**Re: Peer Review of Stormwater Management Permit Application
Nobscot Scout Reservation Trail Improvement Project
1 Nobscot Road, Sudbury, MA**

Howard Stein Hudson (HSH) has reviewed the Horsley Witten Group comments on behalf of the Town of Sudbury dated October 11, 2022 and offers the following responses:

SITE PLAN FOR NOBSCOT SCOUT RESERVATION TRAIL PROJECT SUDBURY AND FRAMINGHAM, MA.

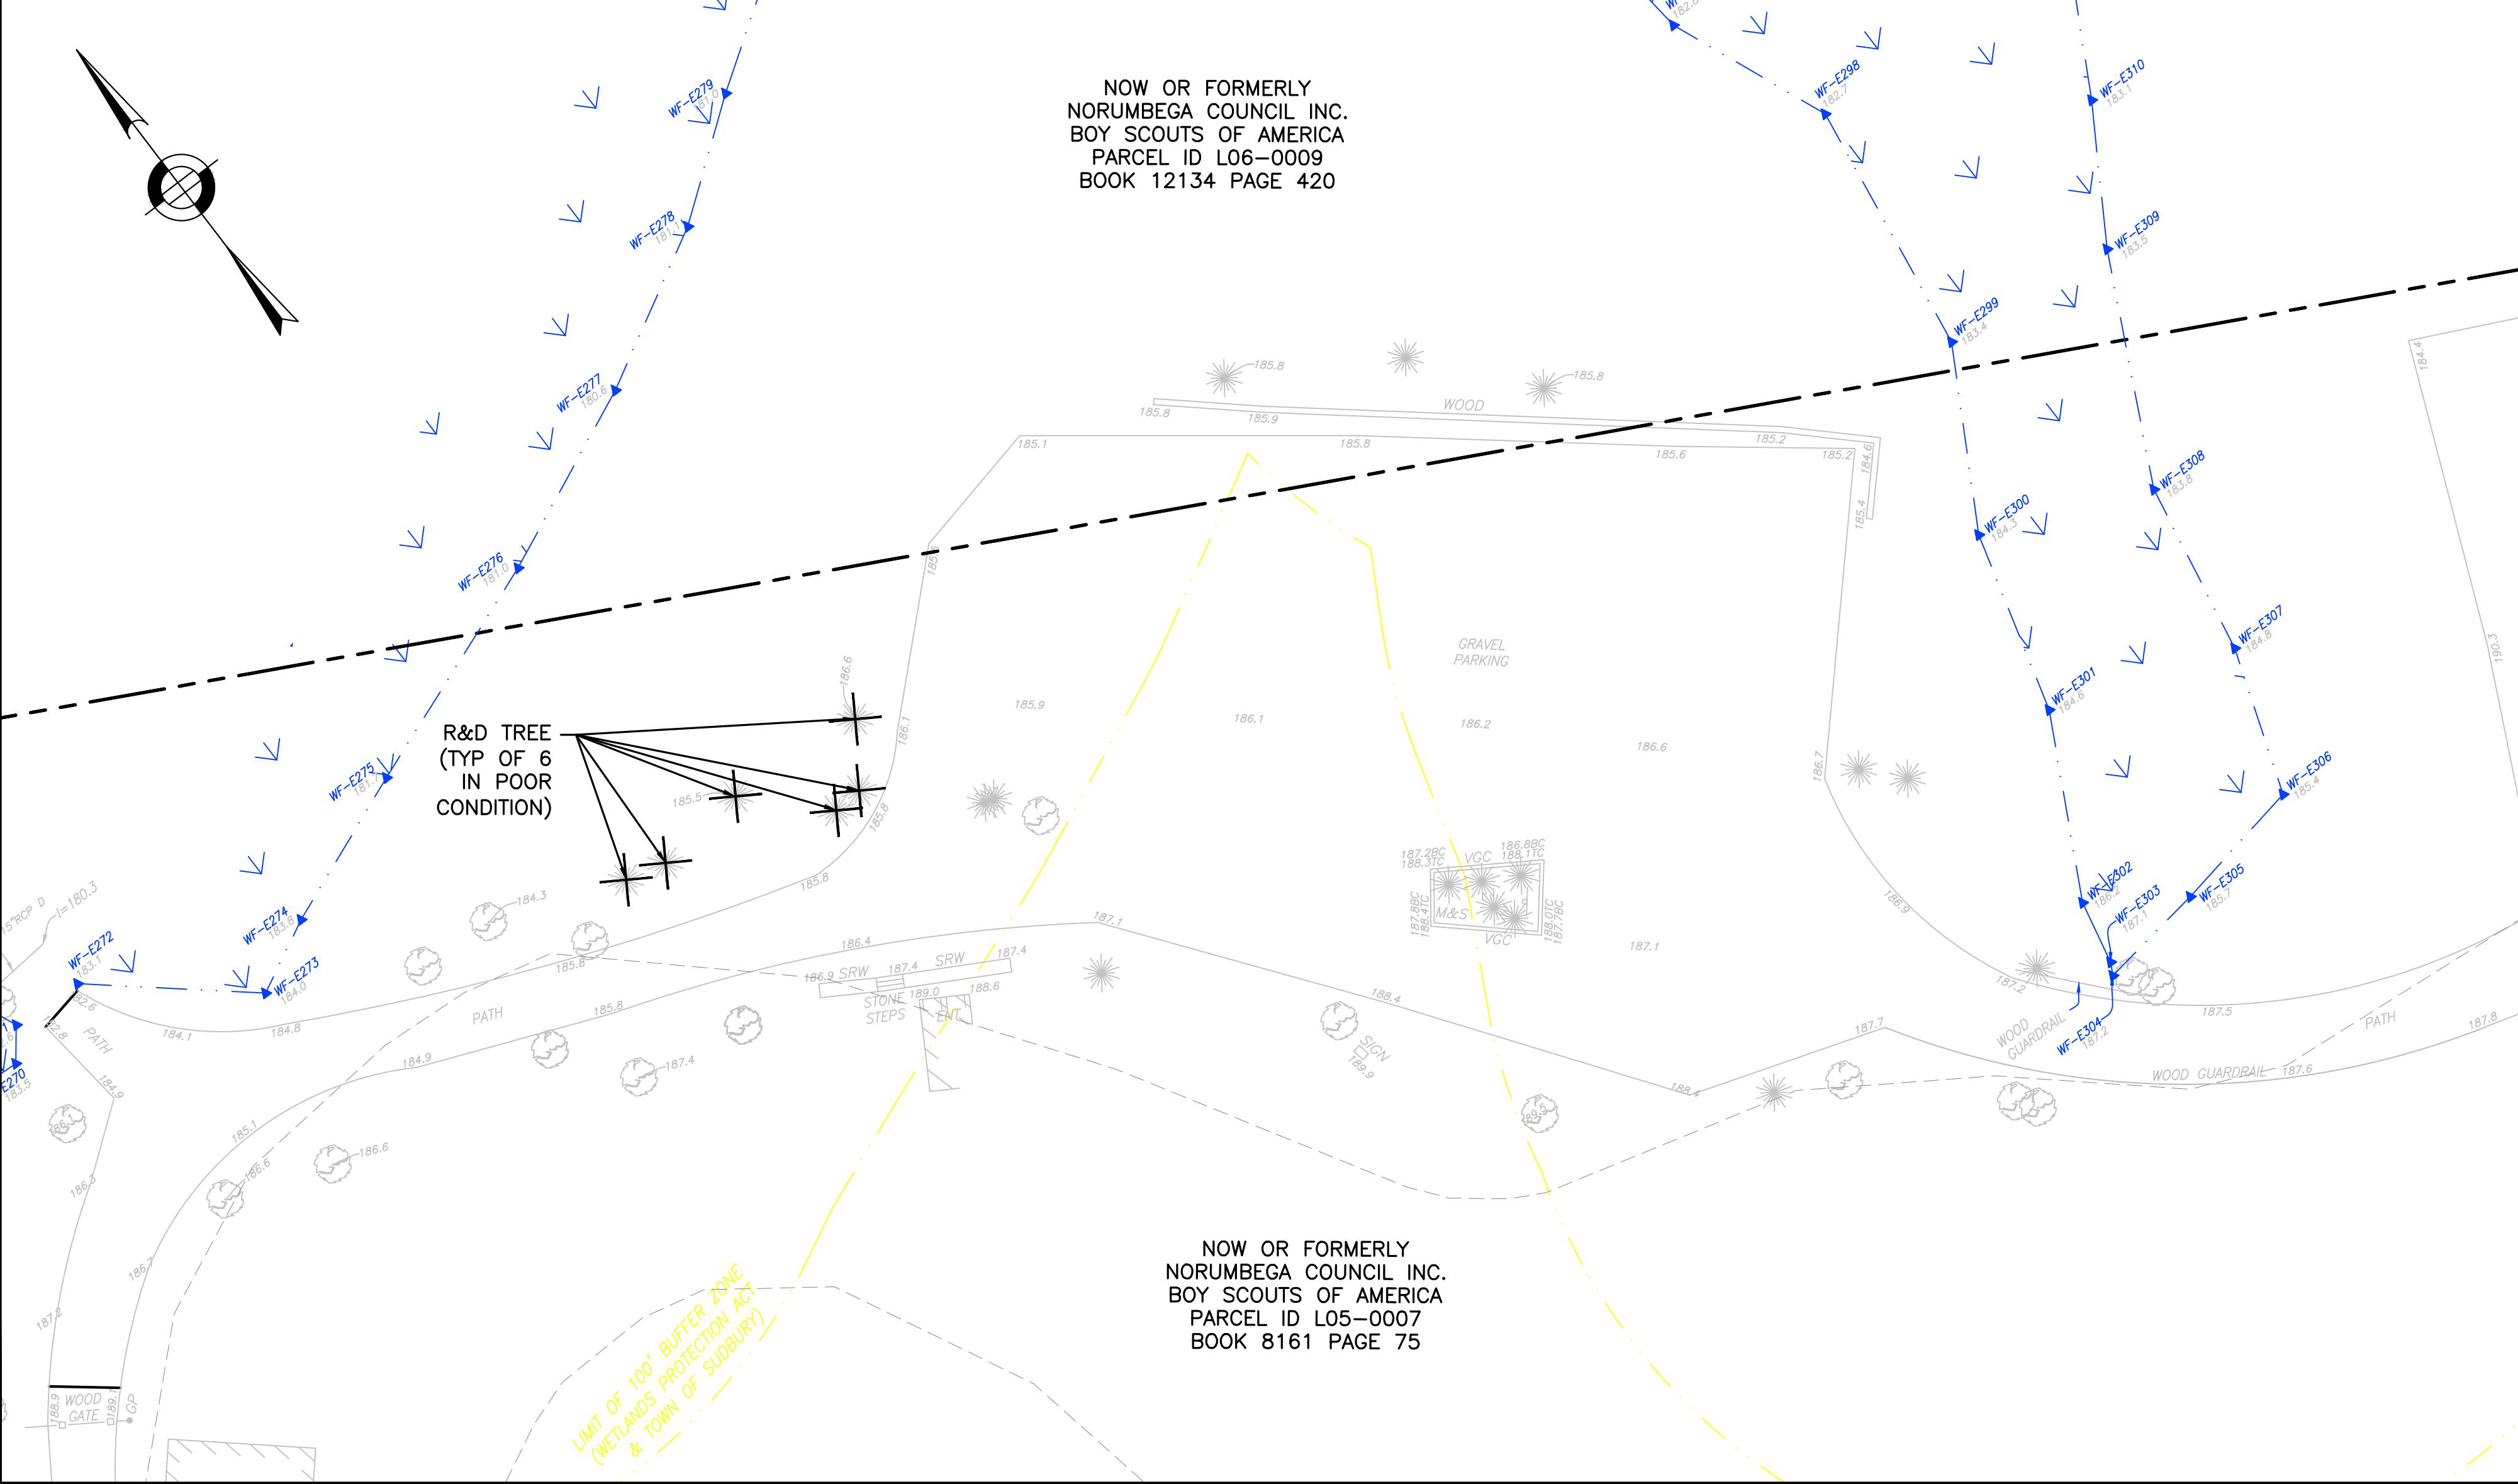
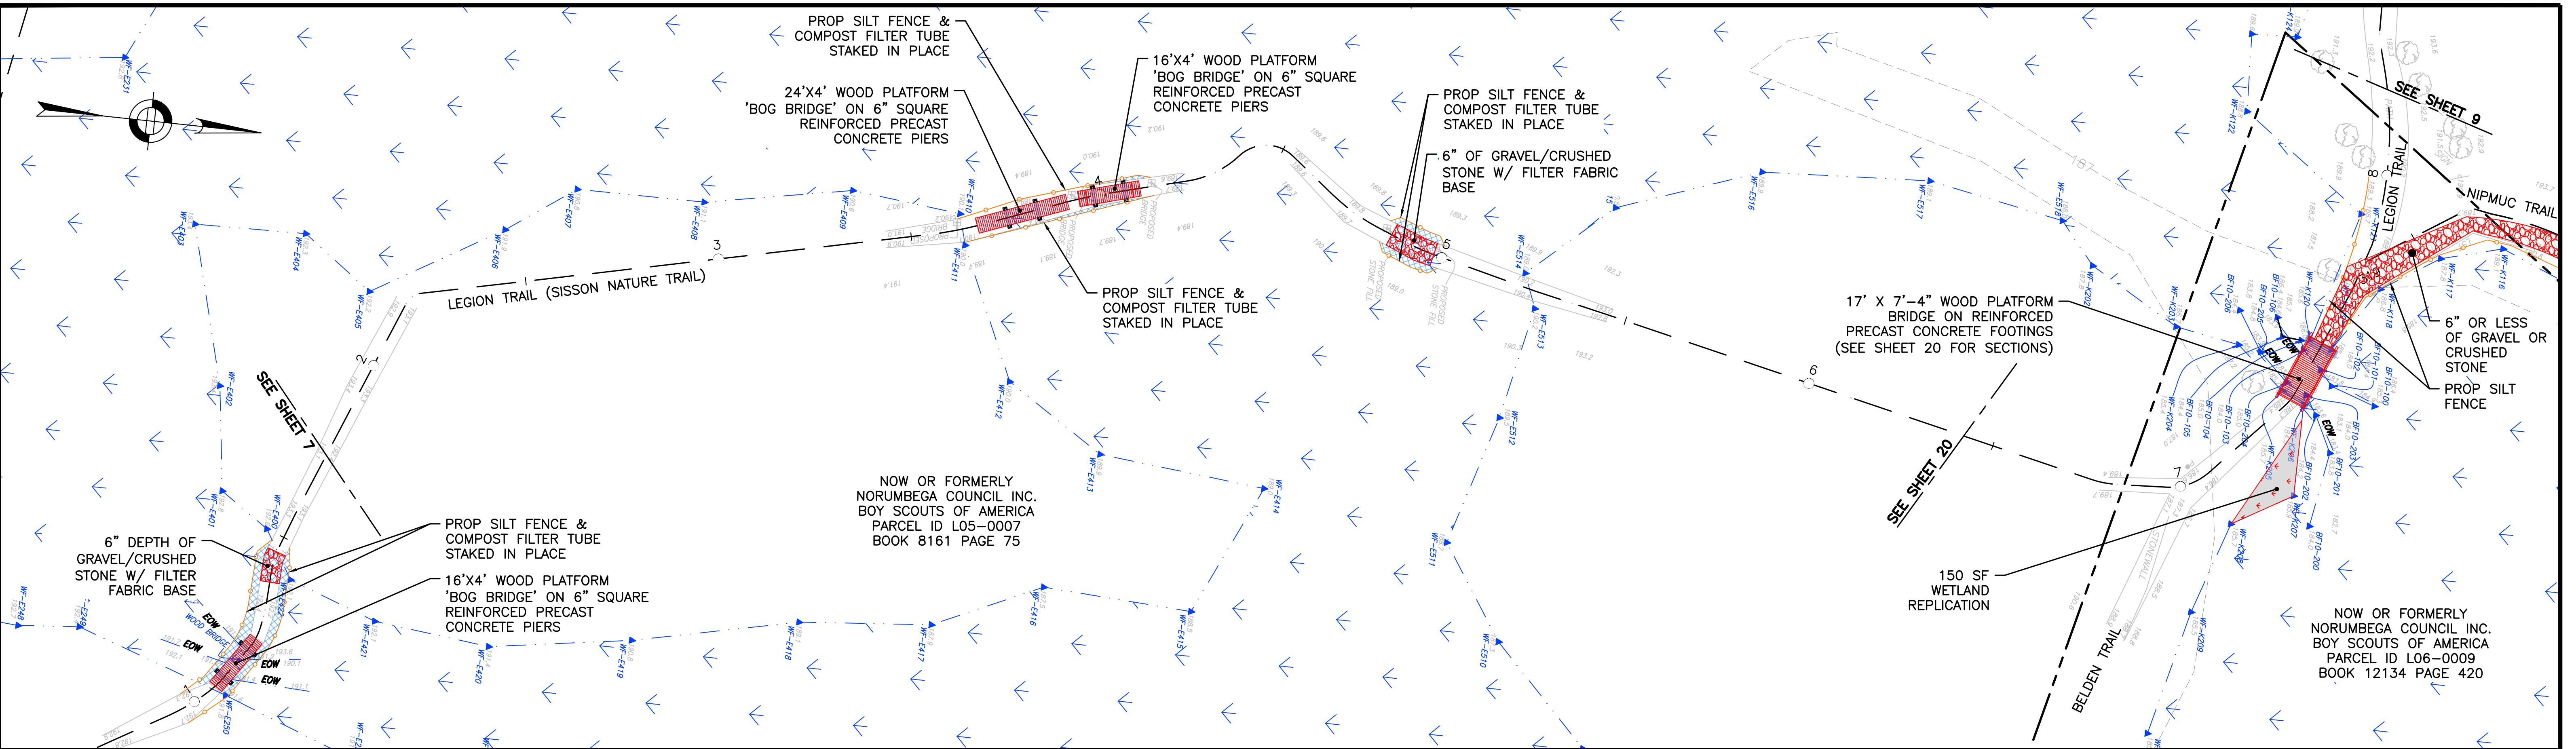
Sheet 8 of 21: Legion Trail – Station 1+00 to 8+00

Comment 19: *Placement of 6-foot-long concrete footings for wooden platform at Station 1+00 to be done by hand. Other footing types instead of heavy concrete footings may be considered.*

Comment 20: *Applicant to review all areas of land disturbance. Areas within wetlands receiving stone should be considered a permanent impact and not temporary.*

Comment 21: *Erosion controls within wetlands should not include trenching of silt fence. Okay to weigh down with silt sock. Measures to be taken to protect turtles during construction.*

Comment: *Applicant can get vehicles to largest bridge replacement between Station 7+00 and 8+00. Plan to widen this bridge.*

Response: As the footings will be lying within wet areas for a significant length of time the most practical material to use is concrete. All work in this area will be completed by hand.

Response: **Work on the existing trails is considered temporary in most locations, except where footings and structures are being installed. Areas of the existing, disturbed trails that are receiving stone are also considered temporary. Currently, these areas consist of compacted gravel and are devoid of vegetation. Where stone is being installed, vegetation will not be altered in the wetland and the substrate, albeit modified, will be restored to existing grade upon completion. The stone will serve to prevent sedimentation into the adjacent undisturbed wetlands, and also serve to prevent pedestrian foot traffic from widening the trails and further altering the wetlands. No wetland loss is proposed at these locations and the impacts are therefore considered temporary in nature and would not require replication. Impact tables have been revised to reflect this as noted in the Lucas Environmental, LLC Notice of Intent Supplement #1 Letter, dated October 24, 2022.**

Response: **Silt fence details has been revised to eliminate trenching previously shown to be replaced by compost filter tubing staked in place where necessary. A turtle barrier entrance detail has been added to the Details sheet.**

Response: **The intent is to widen this bridge to allow for an ATV and the lawn mower to cross the bridge. It will not be large enough to allow for other vehicles such as a pick-up truck to cross.**

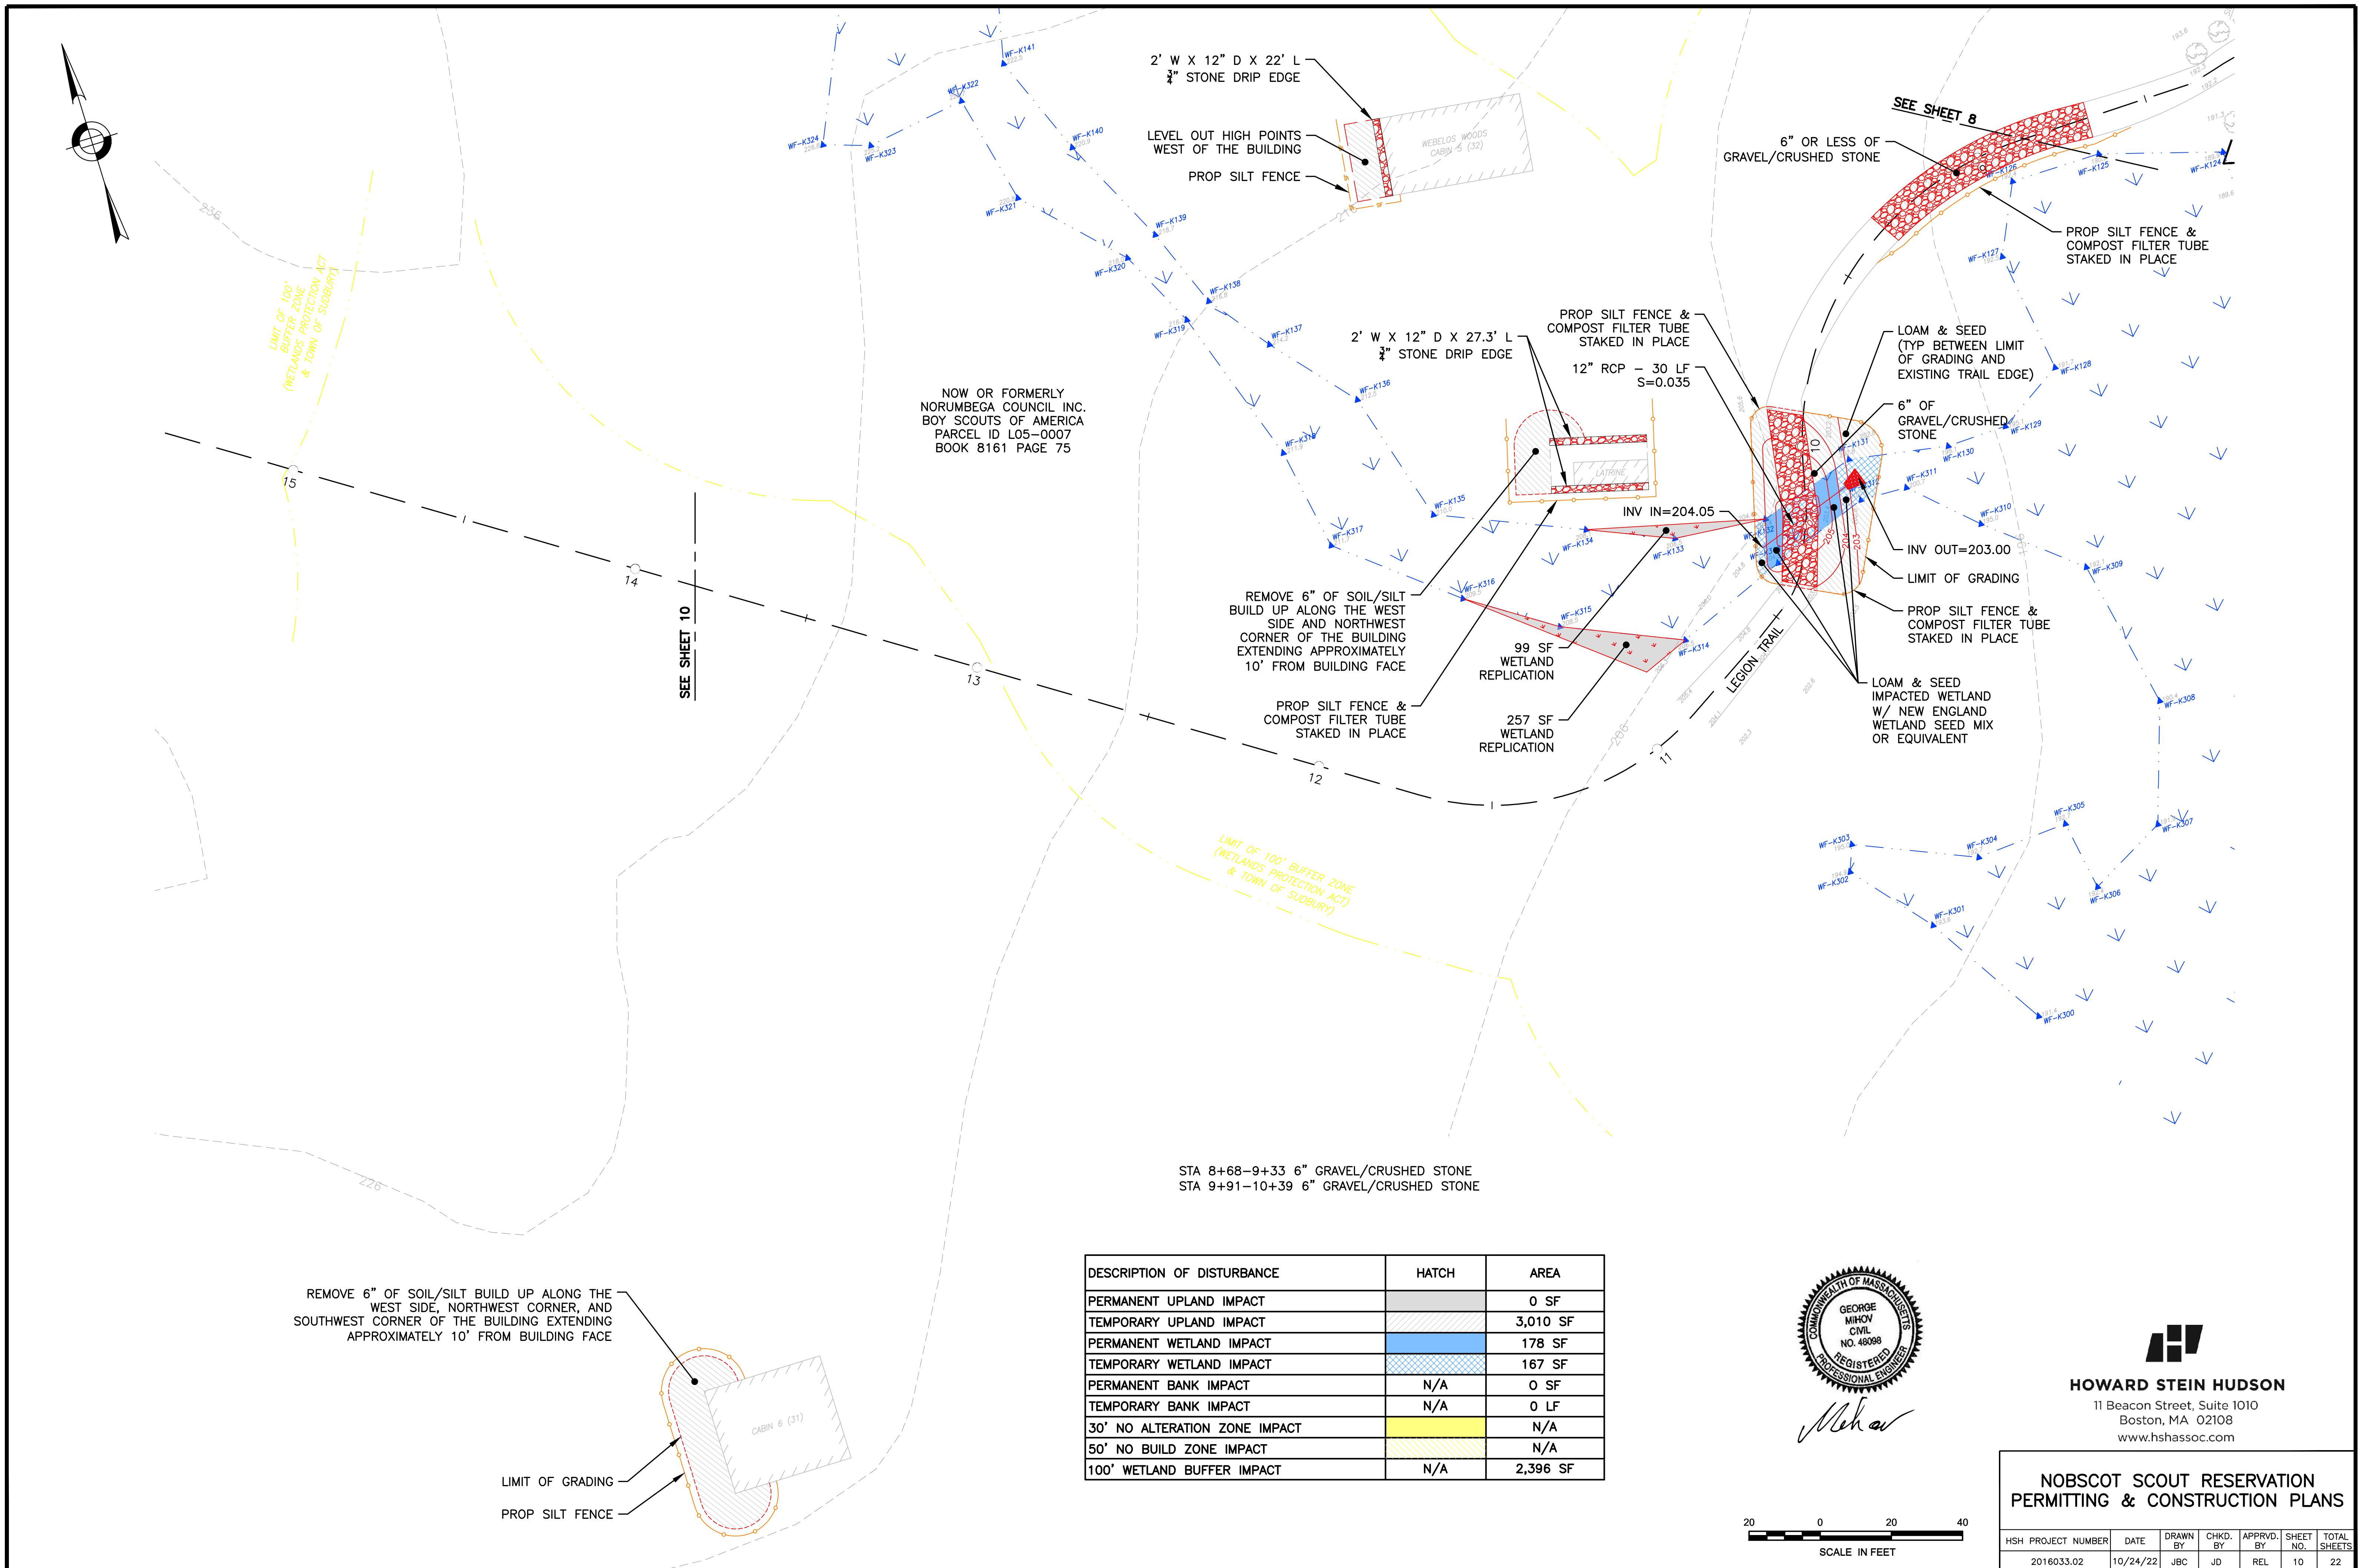
Sheet 9 of 21: Muskie Trail – Station 9+00 to 15+00

Comment: *HW believes trail mislabeled on plan and should be Legion Trail not Muskie Trail.*

- Comment:** *Applicant to review all areas of land disturbance. Areas within wetlands receiving stone should be considered a permanent impact and not temporary. Culvert crossing is permanent impact.*

- Comment:** *Invasive species in this area are a concern, including poison ivy, specifically north side of trail for 25 feet beyond proposed grading, south side is also a problem but not as severe. Invasive management plan should be reviewed with Conservation Commission. Replant disturbed area with shrubs and spray seed mix. Weed Warrior program was discussed. Applicant should explain how it intends to restore the temporary impacts to the wetlands in this area.*

- Comment:** *Work around latrine includes stone trench. Should be placed at roof drip line and not adjacent to building.*
- Response:** Existing building footprints and roof overhang limits have been revised per measurements taken in the field. Stone drip edges are shown at the front and back of the latrine at both sides of the drip line.

- Comment:** *Work around Webelos Woods Cabin 5 includes excavating large rocks. Recommend leaving rocks as it appears difficult to remove them by hand and the need to remove is not obvious. Recommend adding a stone trench at drip line west side of cabin.*

Response: **Trail label has been revised to indicate Legion Trail.**

- Response:** **Work on the existing trails is considered temporary in most locations, except where footings and structures (i.e., culverts) are being installed. Areas of the existing, disturbed trails that are receiving stone are also considered temporary. Currently, these areas consist of compacted gravel and are devoid of vegetation. Where stone is being installed, vegetation will not be altered in the wetland and the substrate, albeit modified, will be restored to existing grade upon completion. The stone will serve to prevent sedimentation into the adjacent undisturbed wetlands, and also serve to prevent pedestrian foot traffic from widening the trails and further altering the wetlands. No wetland loss is proposed at these locations and the impacts are therefore considered temporary in nature and would not require replication. Impact tables have been revised to reflect this as noted in the Lucas Environmental, LLC Notice of Intent Supplement #1 Letter, dated October 24, 2022.**

- Response:** **Temporary impact areas will be loamed and hydroseeded with a wetland seed mix. All upland areas will be hydroseeded. All disturbed areas and approximately 5ft past the limit of work will be monitored for invasives by Lucas Environmental, LLC. The applicant is very interested in the Weed Warrier program and would like to explore that idea with the goal of having some of their volunteers trained to identify and remove invasive species through the trail system.**

- Response:** **Stone removal callout has been eliminated and a stone drip edge has been added along the west side of the cabin.**
